# SETTLERS RANCH

## Filing No. 2C

# Construction Drawings

## El Paso County, Colorado

SETTLERS RANCH RD.  
PLAN & PROFILE  
(STA: 22+00 TO STA: 46+00)

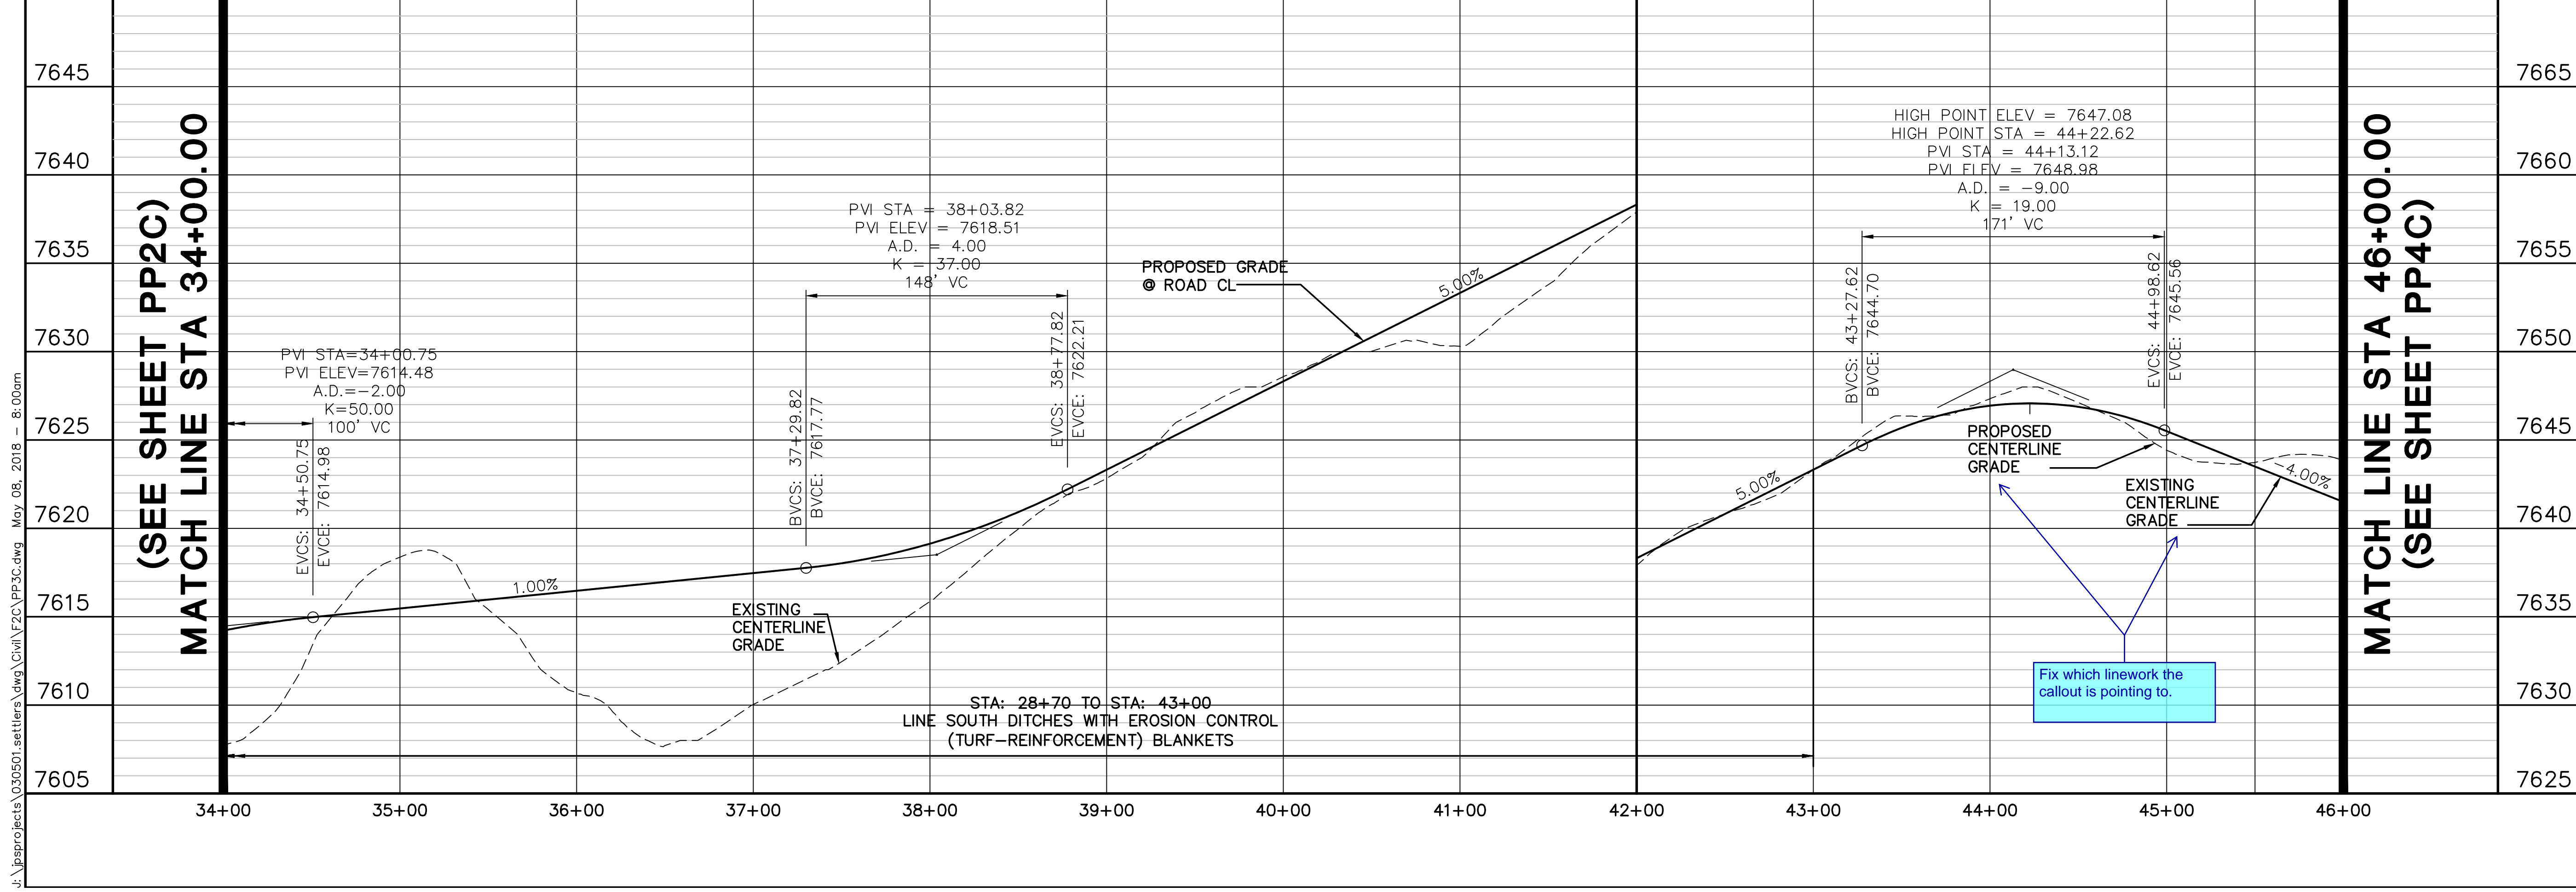
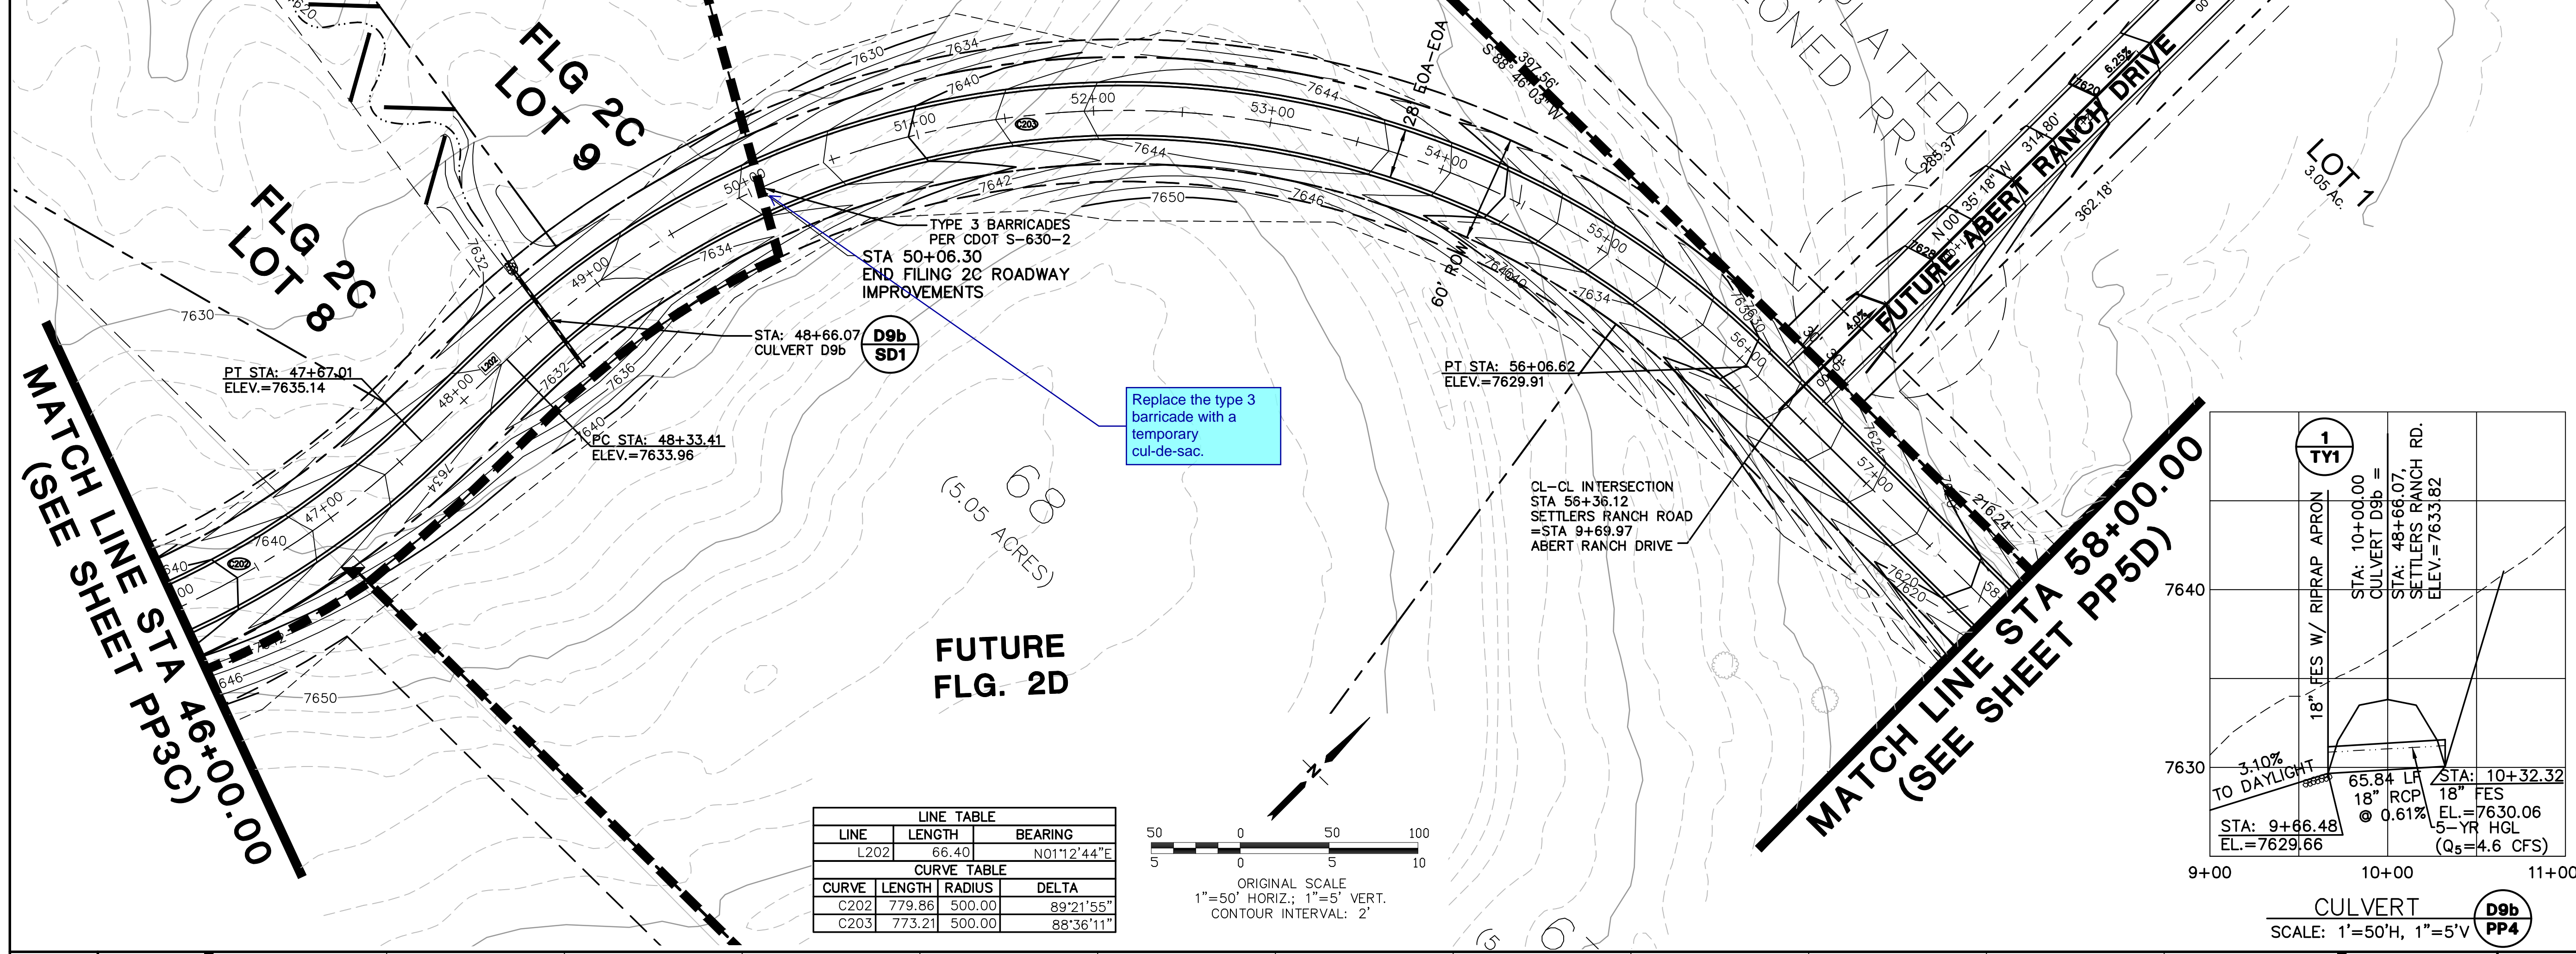
Fix which linework the callout is pointing to.
